TSB # 228-0033
Prince Castle
355 East Kehoe Blvd
Carol Stream, IL 60188
Date 3/17/2017

To ensure on going reliability Prince Castle is issuing TSB # 228-0033 for our CBT-SB-NA-1PS.

CBT-SB-NA-1PS

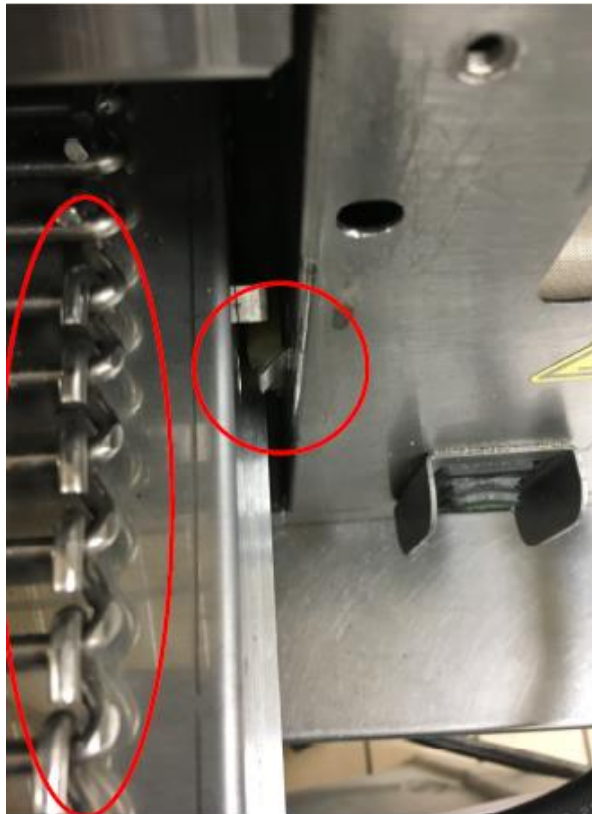
Frame Bracket not bent at 90 degree angle. There is a possibility crew could pull conveyor past stop and pinch motor harness. When this harness extension gets pinched it fries Main PCB driver boards resulting in the conveyor not turning. To correct this issue please bend the bracket at 90 degree depicted below.

Correct

Incorrect
